AMENDMENT OF SOLICITATION/MODIFICATION OF CONTRACT			1. CONTRACT ID CODE	PAGE OF PAGES 1 3
2. AMENDMENT/MODIFICATION NO. 0001	3. EFFECTIVE DATE 28-May-2015	4. REQUISITION/PURCHASE REQ. NO.		5. PROJECT NO.(If applicable)

14. DESCRIPTION OF AMENDMENT/MODIFICATION (Organized by UCF section headings, including solicitation/contract subject matter where feasible.) THE PURPOSE OF THIS AMENDMENT IS TO EXTEND THE RFQ DATE FROM 5/29/2015 TO 6/2/2015 AT 5:00 PM EASTERN TIME AND TO PROVIDE QUESTIONS AND ANSWERS. NO MORE QUESTIONS WILL BE ACCEPTED AS OOF 5/28/2015.				
Except as provided herein, all terms and conditions of the document referenced in Item 9A or 10A, as heretofore changed, remains unchanged and in full force and effect.				
15A. NAME AND TITLE OF SIGNER (Type or print)		16A. NAME AND TITLE OF CONTRACTING OFFICER (Type or print) JESSICA L. NELSON / CONTRACT SPECIALIST TEL: (215) 897-8877 EMAIL: jessica.nelson@navy.mil		
15B. CONTRACTOR/OFFEROR _____ (Signature of person authorized to sign)	15C. DATE SIGNED	16B. UNITED STATES OF AMERICA BY _____ (Signature of Contracting Officer)	16C. DATE SIGNED 28-May-2015

THE PURPOSE OF THIS AMENDMENT IS TO INCORPORATE THE QUESTIONS AND ANSWE

IMPROVEMENTS SITE PLAN
SCALE: 3/8" = 1'-0"

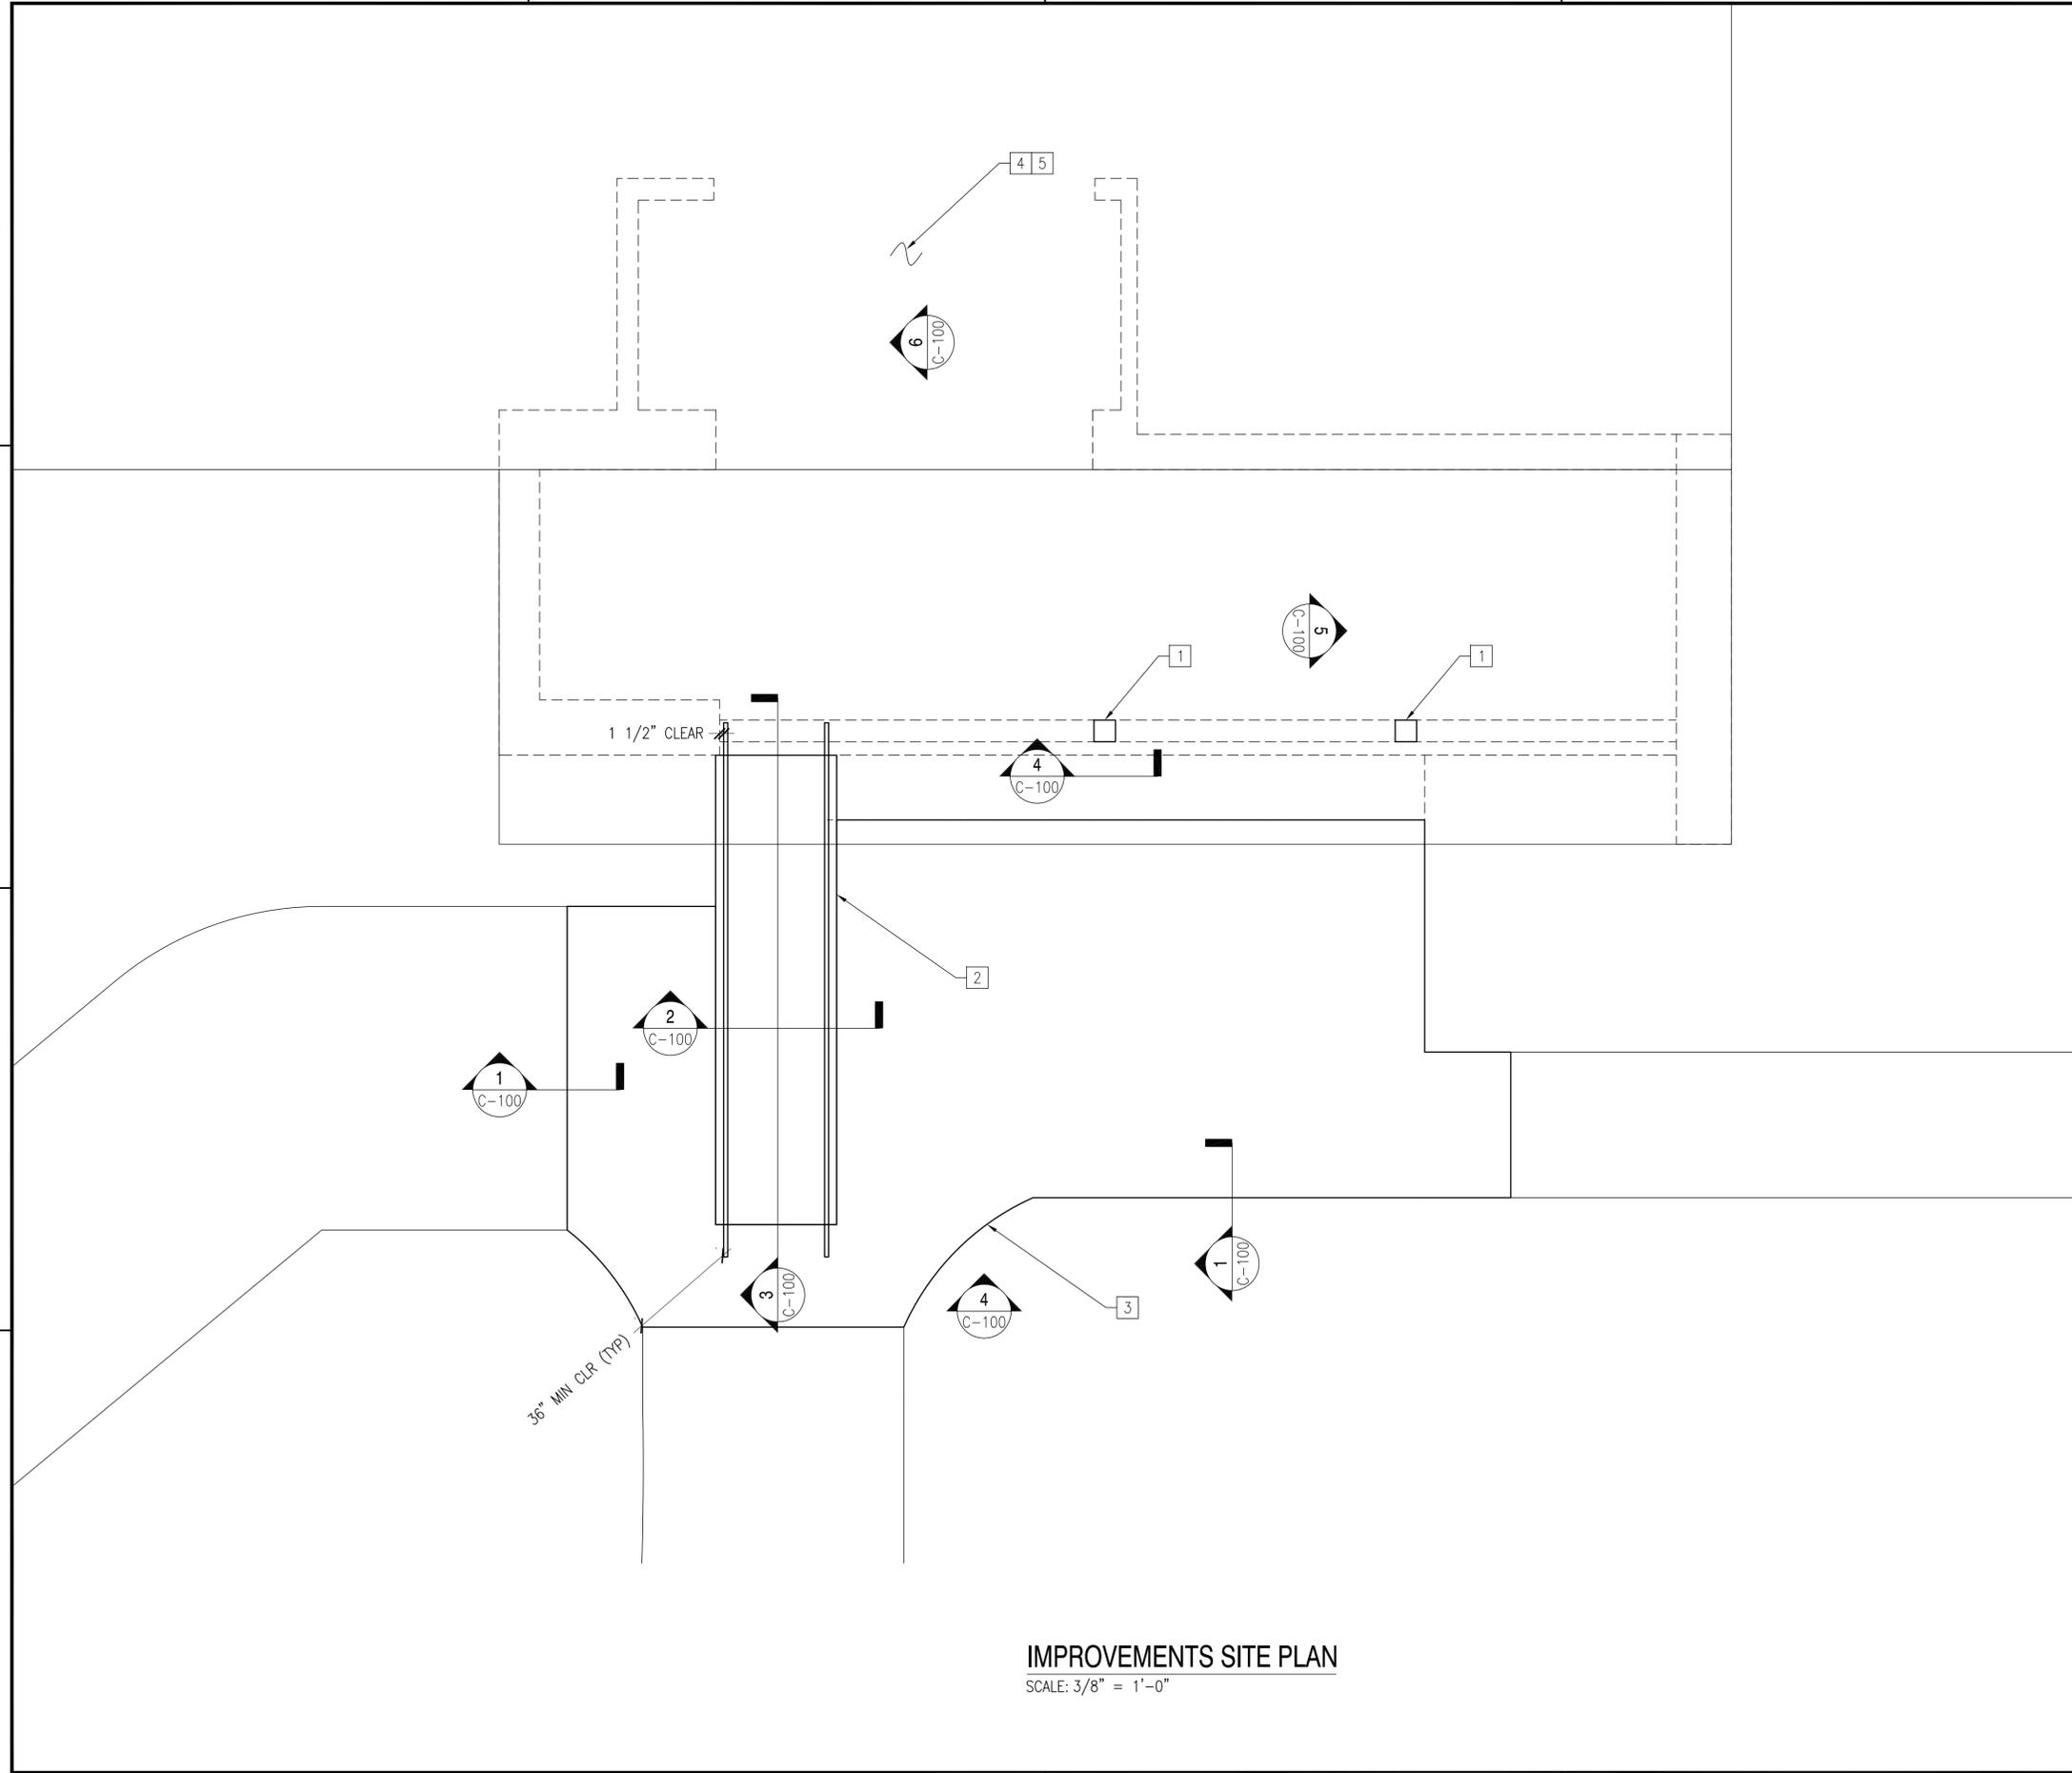
- 1) The drawings downloaded from the NECO site has a completion status of Preliminary. Are there drawings with a higher percentage completion status for bid?
- 2) Are there existing drawings of the slab where the base of the shoring will be supported? If so, can you make them available to us?
- 3) What is the minimum curing time are you allowing for the new concrete before it can be painted?
- 4) What are your recommendations for treating the spalding in the concrete ceiling?
- 5) Please advise of the dimensions showing the extent of the new side walk and its proximity to the end of the pipe rail
- 6) Frost depth in the area of construction is 30". The embedment depth specified for your turn-down-footings is 1'-6". Please advise if you want us to use the 1'-6" turn-down-footing embedment for our estimate.

- 1) Noted as "Preliminary" for pre-award solicitation/bid, will be removed upon award.
- 2) See attached excerpt from original as-builts, we make no warranties to drawings representing the existing field conditions.
- 3) Contractor's means and methods
- 4) Prepare areas of spalled concrete ceiling (down to solid material), repair with approved cementitious grout suitable for application at existing condition. To be prepared and installed per approved product's manufacturers specifications.
- 5) See Demolition Site Plan (C-001) and Improvements Site Plan (C-002).
- 6) Confirmed, the construction embedment is exempt from frost depth requirements.
